Attachment C

**Sydney Development Control Plan 2012
Policy and Housekeeping – Overview and
Explanation**

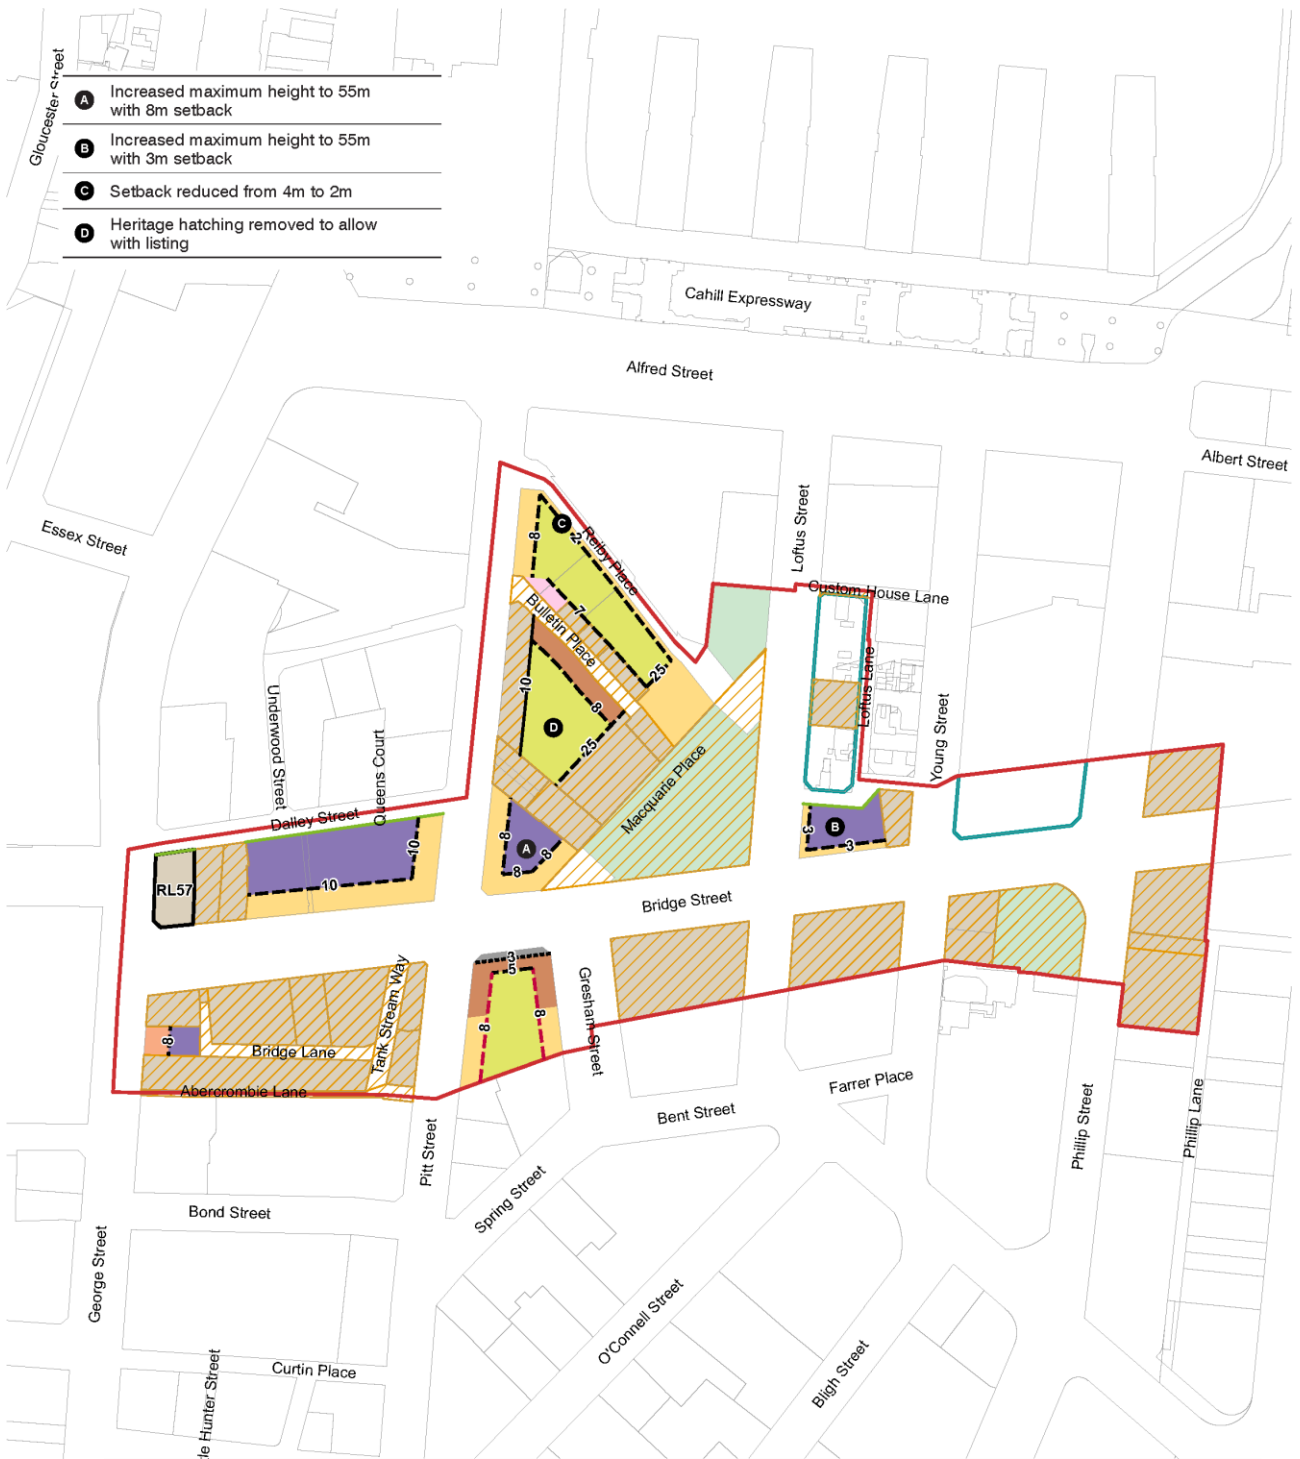
The current provisions require a street wall height of 15m (with the exception of George Street, Harbour Street and a small section on Sussex, Goulburn and Factory Streets) with an 8m setback above the street wall. For small and irregular shaped sites, this can result in a significant loss of floor space and in small building floorplates which are often unviable for commercial uses. For most small sites in the special character area, the FSR is not achievable once the street wall height and setback are applied. Development therefore is not possible without amalgamation, which would result in the loss of the historic ownership pattern and fine grain character of the area. This has also contributed to a lack of renewal in Haymarket and Chinatown.

To address this, the special character area map is proposed to be updated to increase the street wall height to 35m in most instances. With a street wall height of 35m, the majority of sites can achieve their FSR, allowing fine grain renewal.

Amenity benchmarking has demonstrated that the street wall height can be raised to 35m without detrimental effects to the daylight in the public domain.

Figure 5.5

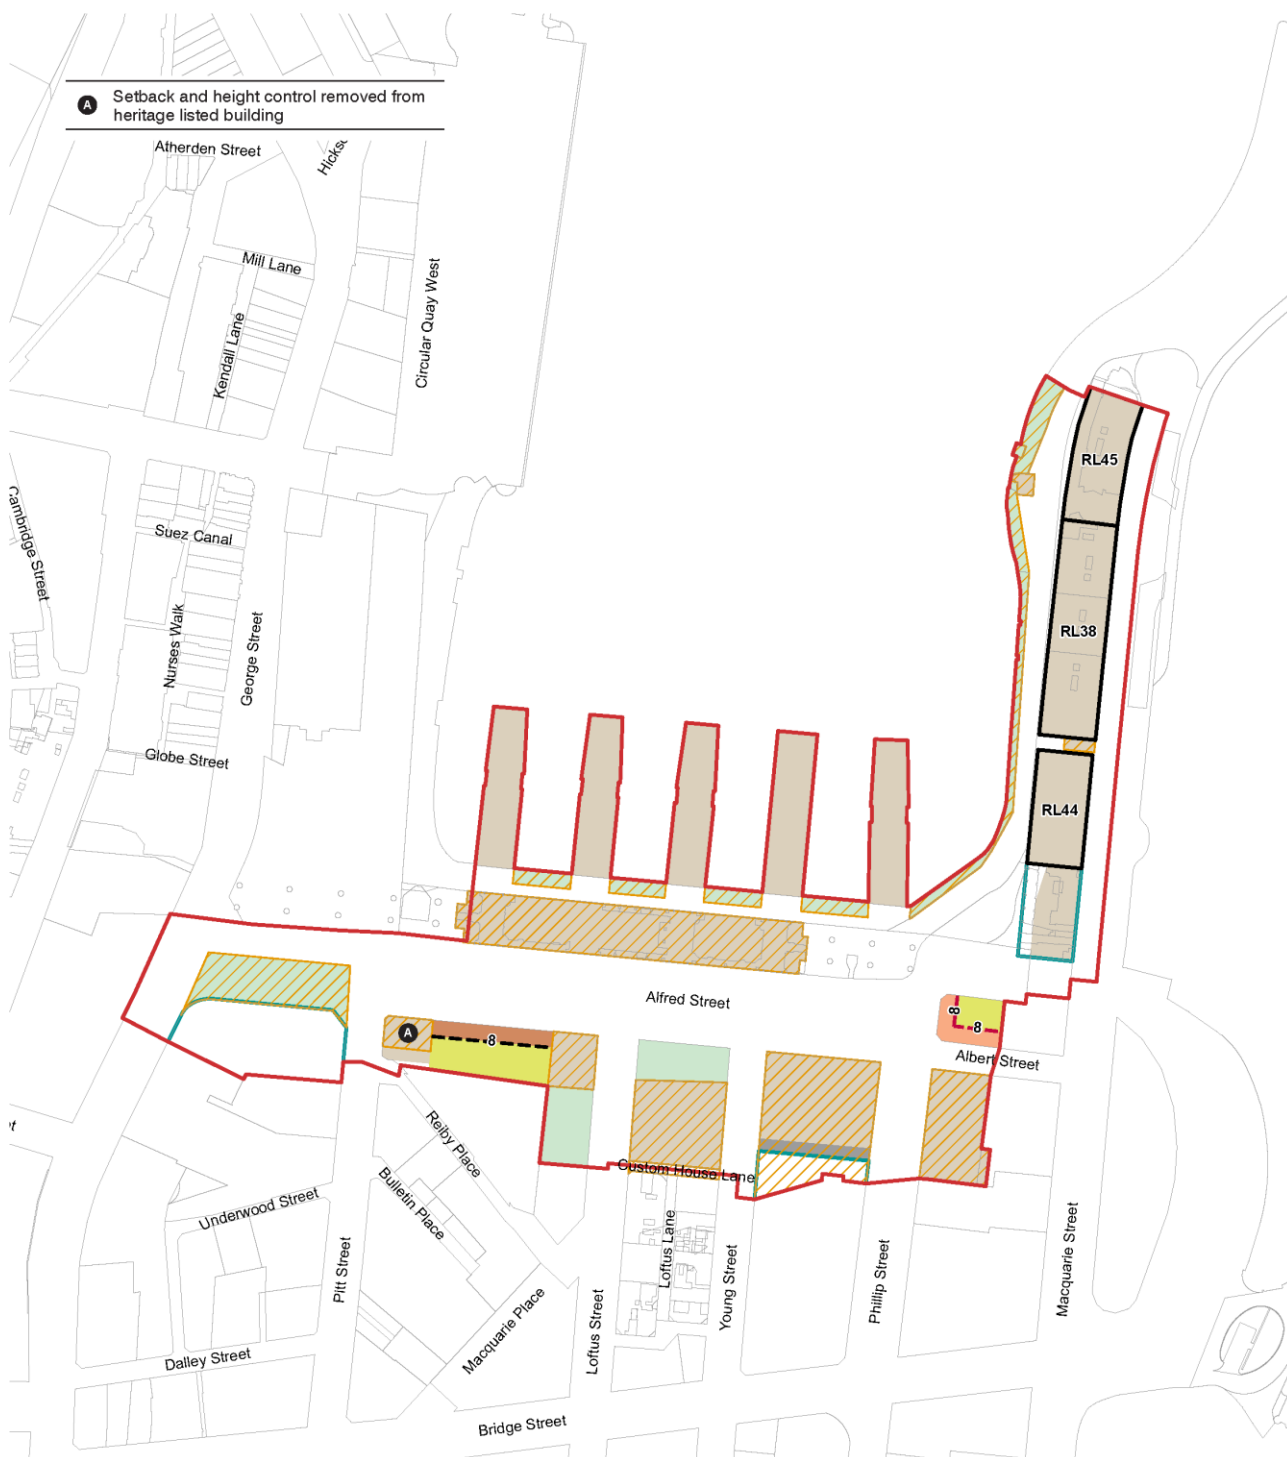
A Setback and height control removed from heritage listed building

Figure 5.8

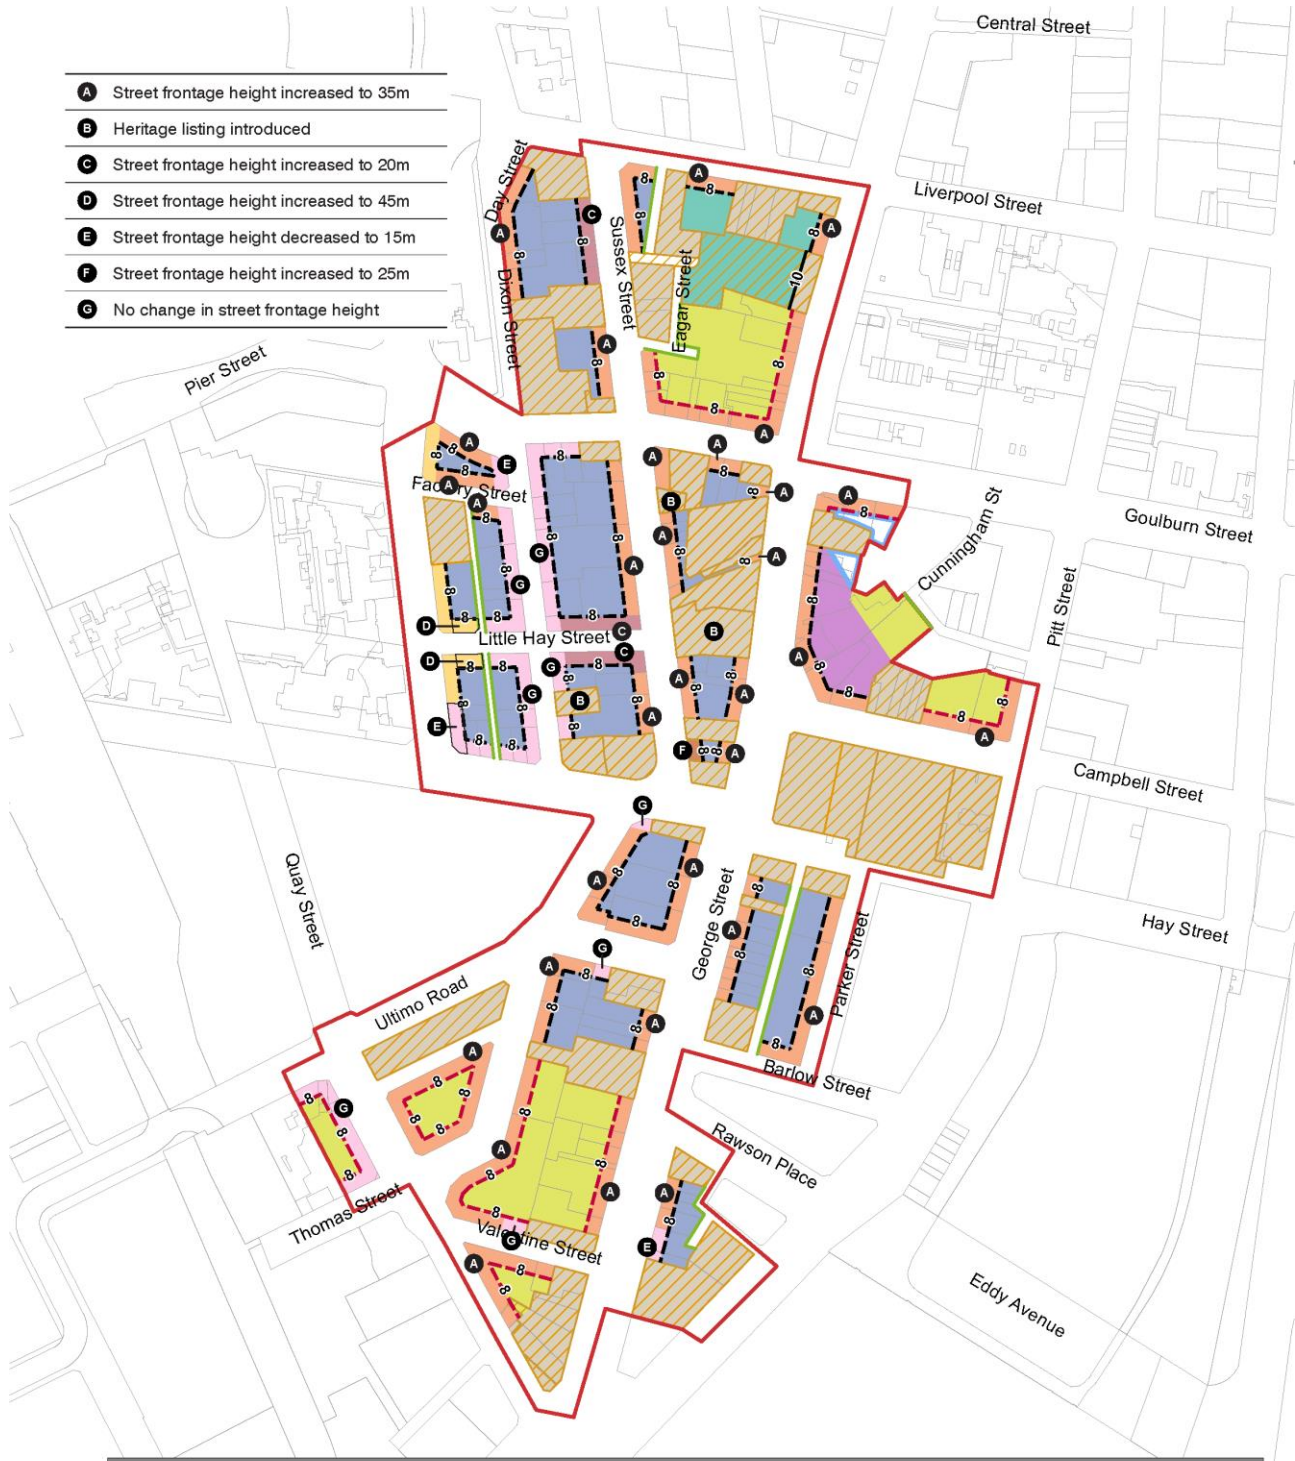
- A** Street frontage height increased to 35m
- B** Heritage listing introduced
- C** Street frontage height increased to 20m
- D** Street frontage height increased to 45m
- E** Street frontage height decreased to 15m
- F** Street frontage height increased to 25m
- G** No change in street frontage height

Figure 5.10

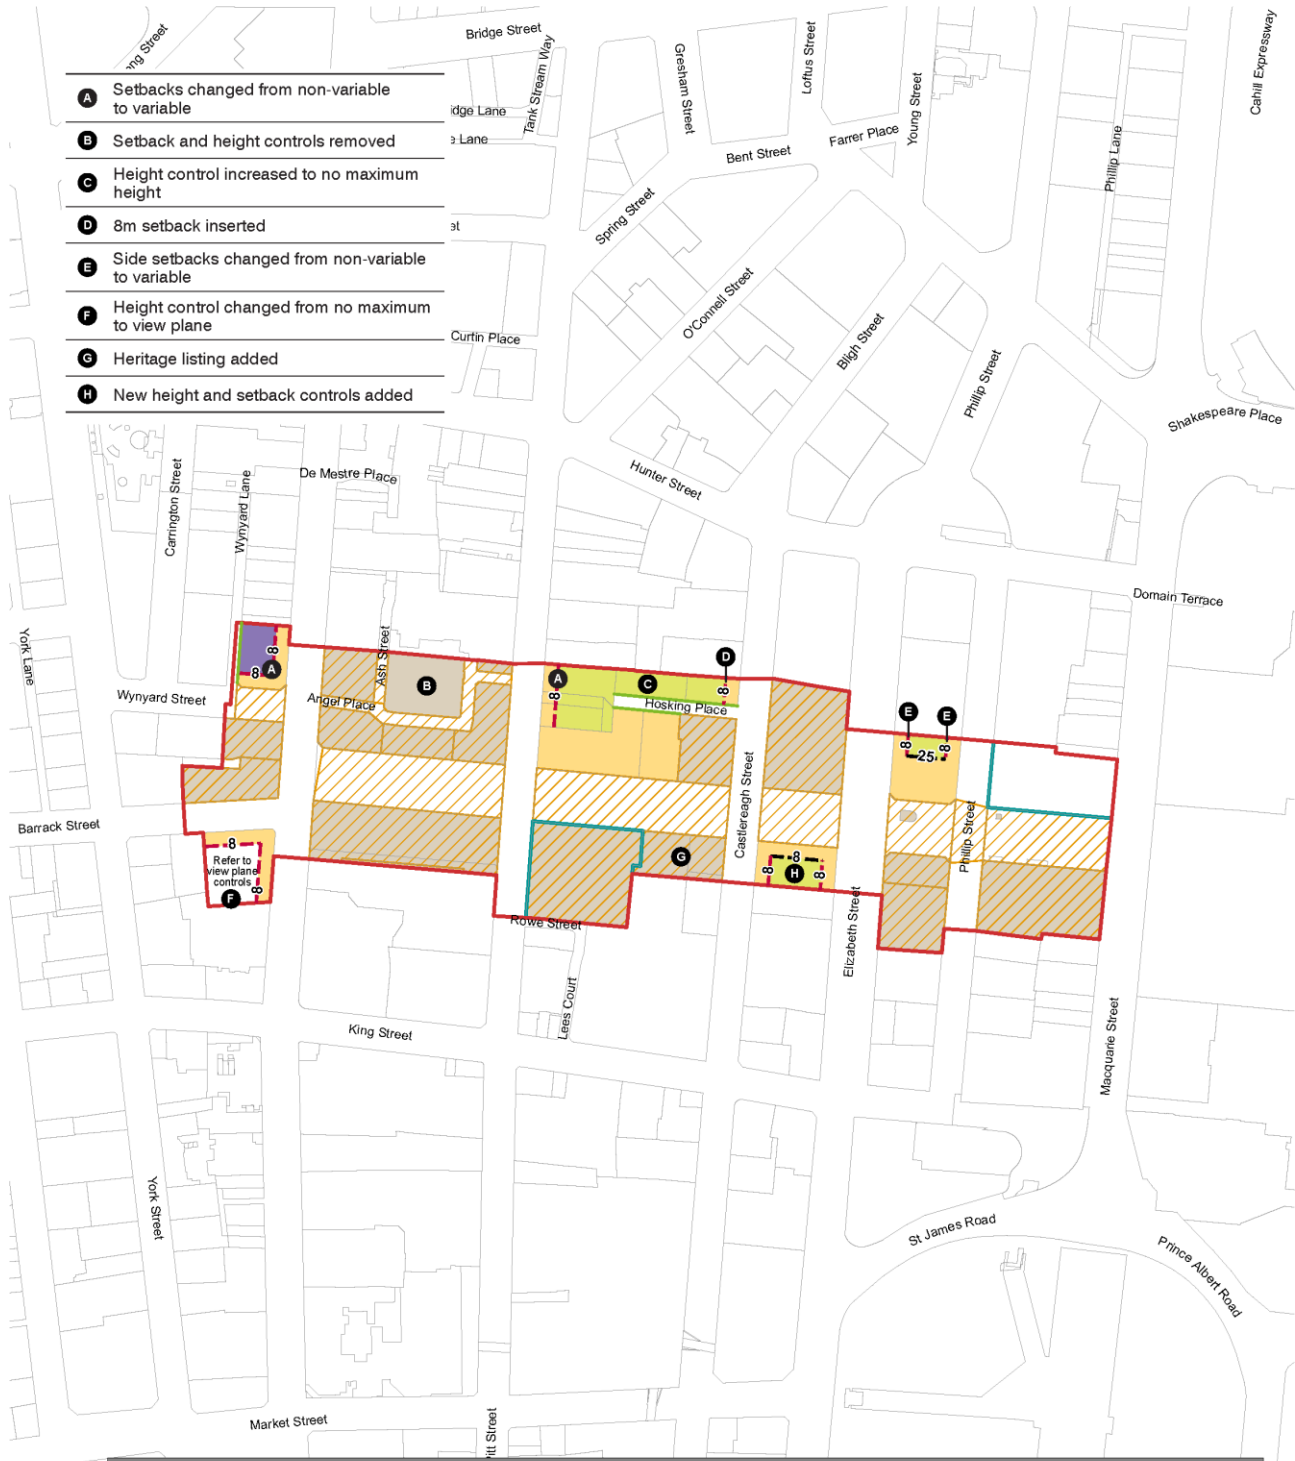
- A** Setbacks changed from non-variable to variable
- B** Setback and height controls removed
- C** Height control increased to no maximum height
- D** 8m setback inserted
- E** Side setbacks changed from non-variable to variable
- F** Height control changed from no maximum to view plane
- G** Heritage listing added
- H** New height and setback controls added

Figure 5.13

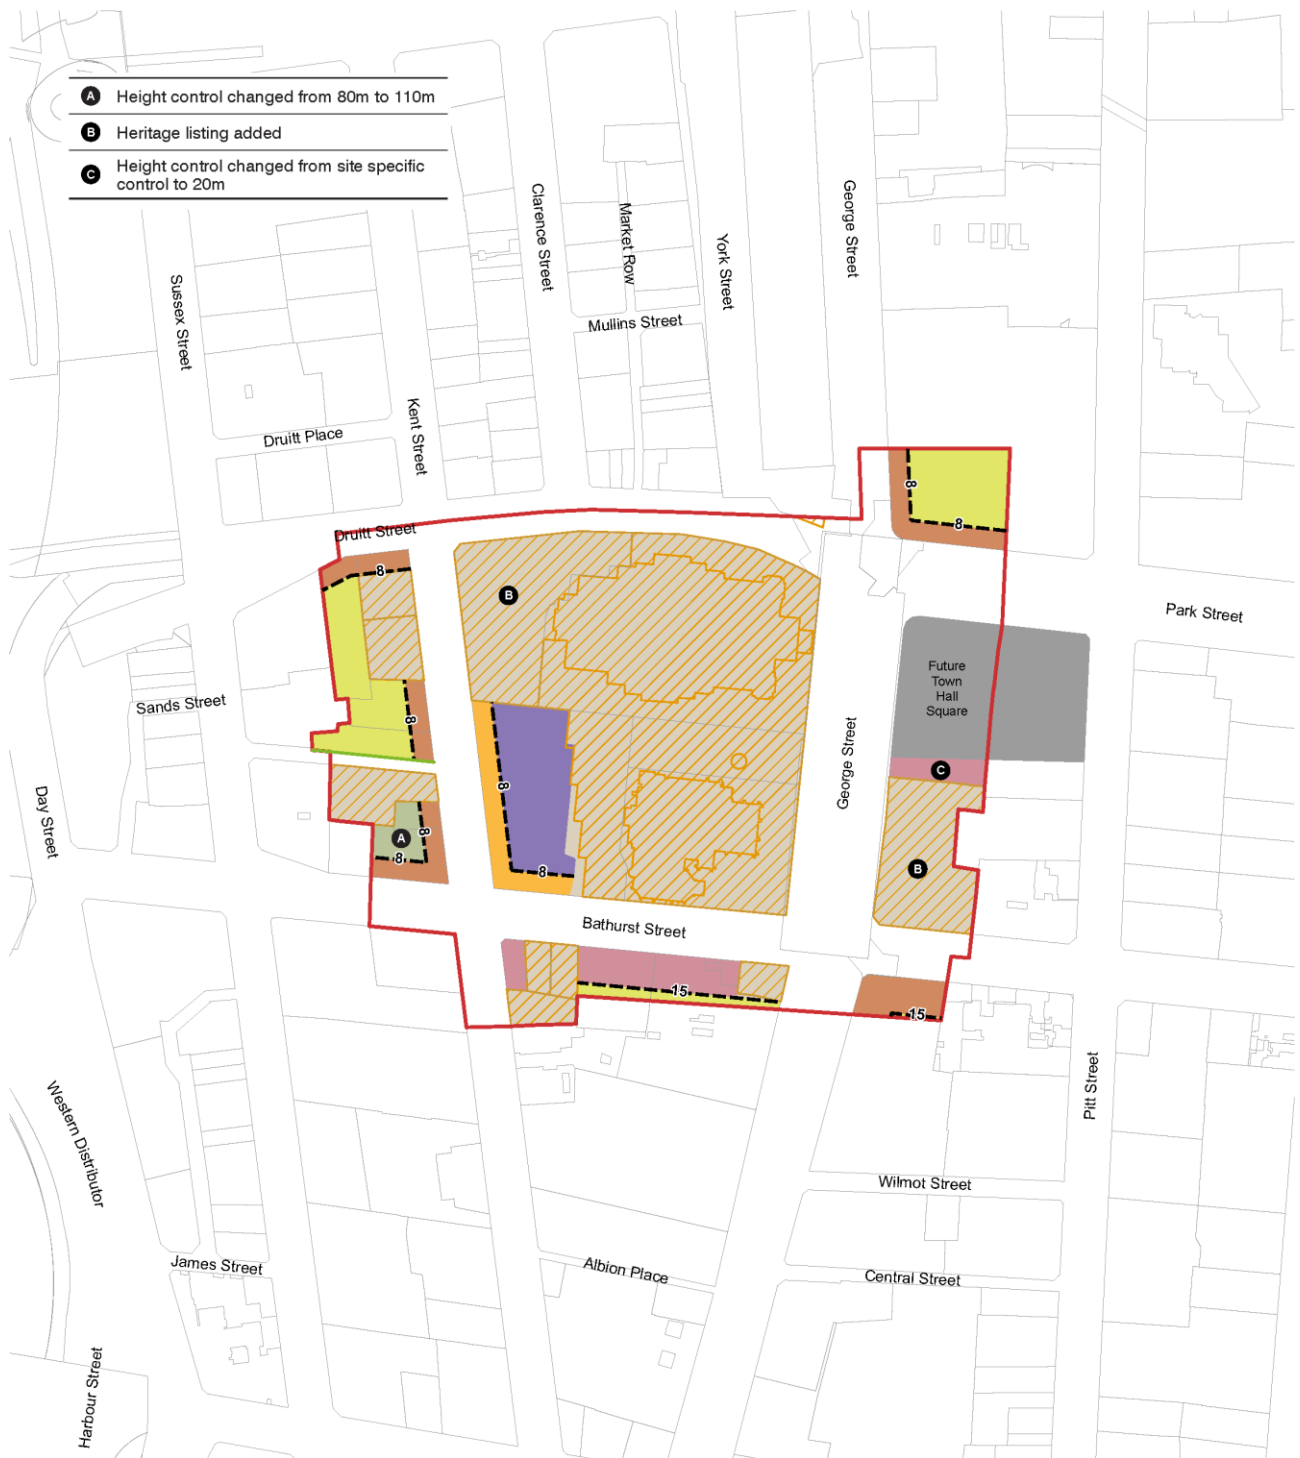
- A** Height control changed from 80m to 110m
- B** Heritage listing added
- C** Height control changed from site specific control to 20m
